REMARKS

Respectfully submitted,
SPRITE SOLUTIONS
By its attorneys:

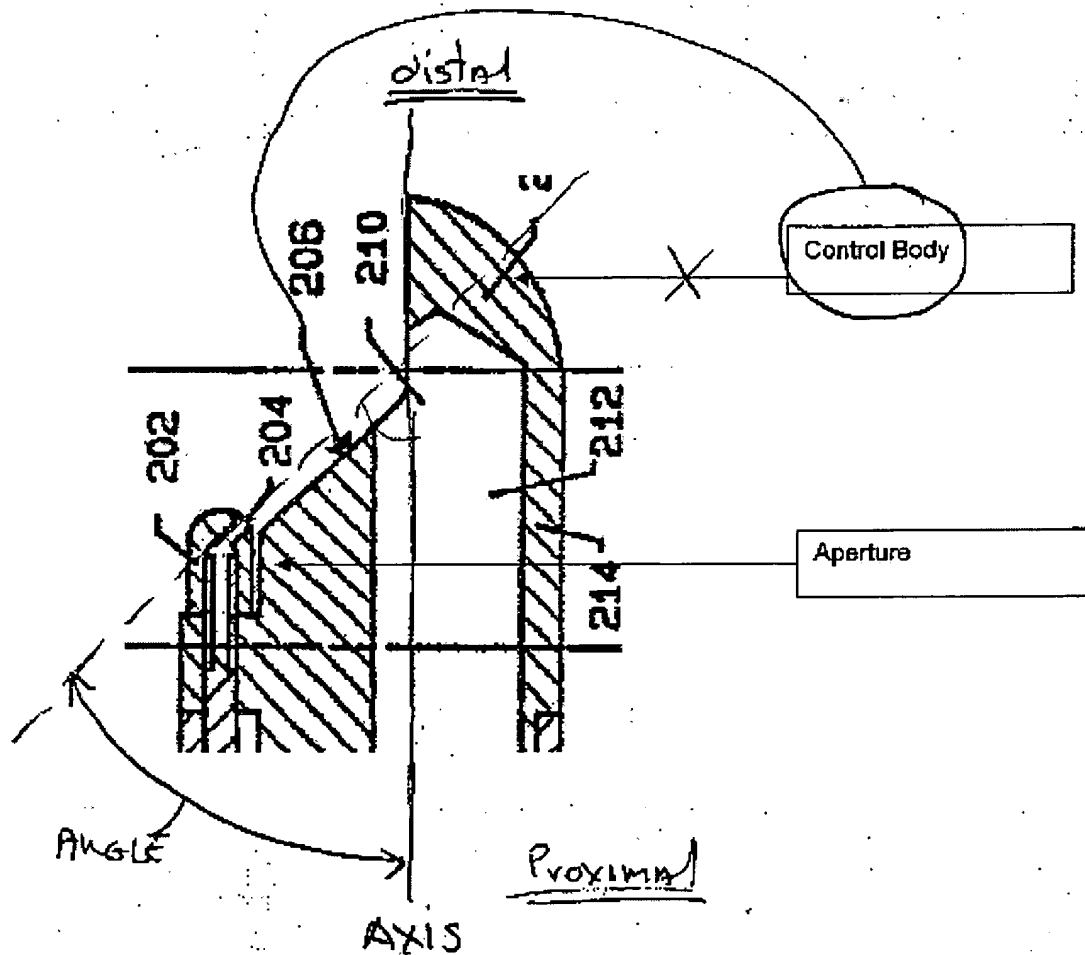
Applicant's position is best understood with reference to the figure below drawn from the Examiners action.

In the figure the central axis is marked "axis" and the relevant angle between the axis and the aperture is marked "angle". As this angle approaches zero the aperture turns and ejects fluid more toward the proximal end. Therefore claim 19 does not describe this Drasler construction. Also please note that the control body near the aperture is more accurately identified in the figure by element 206.

In essence the claimed geometry requires that the primary jet shoot out laterally to rearwardly, in contrast to the Drasler primary jet emerging from orifice 204 which shoots forward and inwardly. For this reason the claim as written is not anticipated. Dependant claims 21 and 22 are free of this reference as dependent claims.
